CHANGE ORDER FORM

Project Title: Ankeny Kirkendall Public Library
Contractor: Stahl Construction
Address: 1250 SW District Dr.
Finance Budget Code: 928.2928.4412 **Finance Project #** 928.4412
Vendor Project or Invoice #: 0 **PO #** 0
Original Contract Date: April 2, 2018 **Vendor #** 7227

Change Order Number: 5

ADDITIONAL METAL FRAMING AND WELDING TO FORTIFY THE ROOF MONITORS.

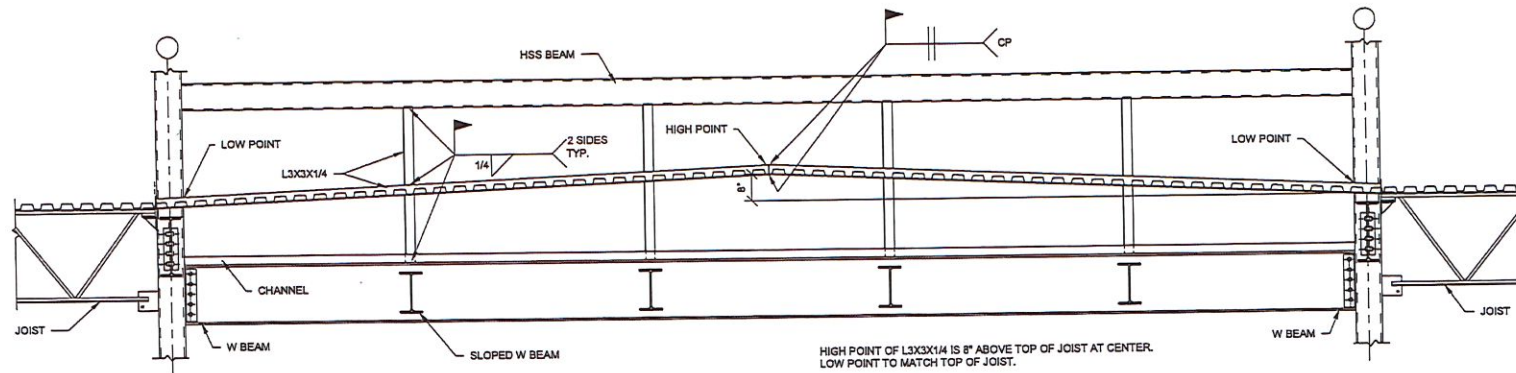
There is an architectural detail, G9/A320 that shows an angle that supports the decking and framing above at the Roof Monitors at grid lines 4 and 5. This configuration is not shown in the structural drawings. Please advise with a size and configuration for the single.

Provide a 3X3X1/4 continuous angle supported by a 3X3X1/4 column angles and HSS 2X2X1/4 tube to support the deck as shown in the attachment. This occurs between grid lines B and C at grid lines 4 and 5.
